SERVICE INFORMATION

YS-013 -07

SUBJECT: S1-37319831001 One-Piece Motor Bracket For Residential - Furnaces, Air Handlers and Package Units

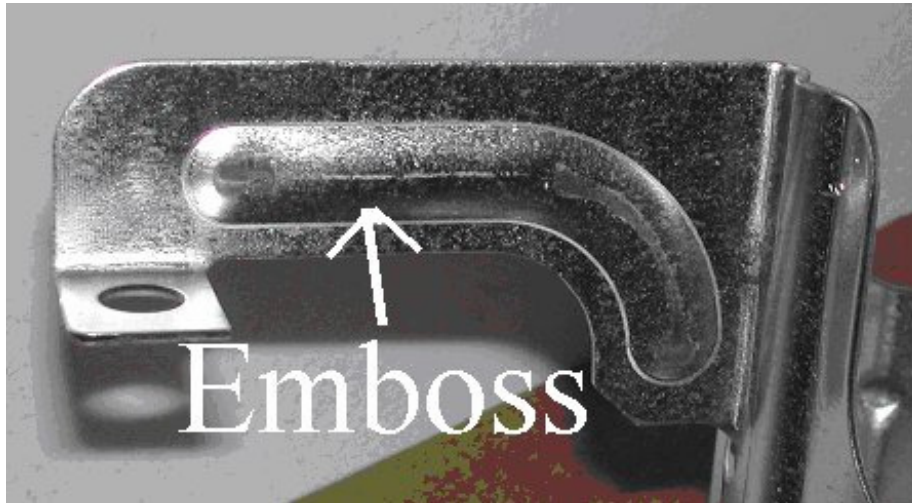
To resolve field complaints of blower wheels coming apart the one-piece motor bracket has been modified. Because of motor bracket legs flexed on start up torque caused the hub in blower wheel to come loose, resulting in several wheel failures.

The brackets now have embosses in the legs, adding strength.

Source 1 inventory has been purged and brackets are now being used in production. New bracket will be assigned part number S1-37319831002.
